**WATTS BAR NUCLEAR PLANT (WBN) - TECHNICAL SPECIFICATION CHANGE  
TS-01-04, DIESEL GENERATOR (DG) RISK INFORMED ALLOWED OUTAGE TIME  
(AOT) EXTENSION - REQUEST FOR ADDITIONAL INFORMATION AND  
SUPPLEMENT TO AMENDMENT REQUEST**

**Enclosure 1**  
**NRC Request for Additional Information**  
**From the Review of TVA's Letter Dated August 7, 2001**  
**Technical Specification Change TS-01-04**  
**Diesel Generator (DG) Risk Informed Allowed Outage Time (AOT) Extension**

**Enclosure 2**  
**Response to NRC's November 28, 2001,**  
**Request for Additional Information and**  
**Supplemental Response to TVA's Letter Dated August 7, 2001**

**Spectrum of Application Effectively  
Supported by the PSA**

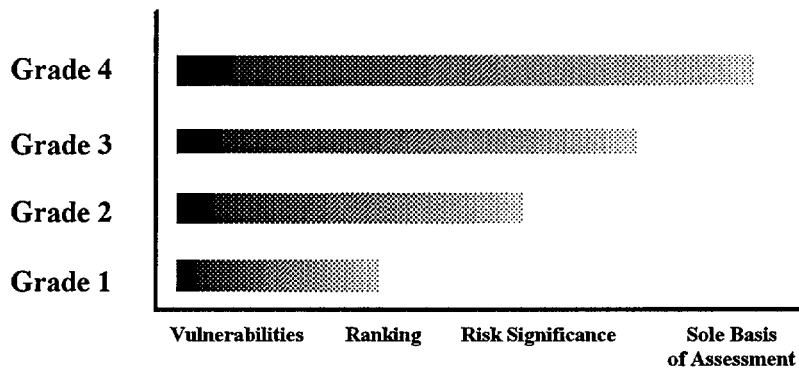
It should be noted that each of the PSA elements listed above were graded by the review team using the following scale. The assigned grades are reflected in the above table and indicate that the WBN PSA is basically adequate for risk informed applications once the specific review observations are addressed. The information provided in this enclosure discusses the relevant observations and TVA's initial disposition of the observations:
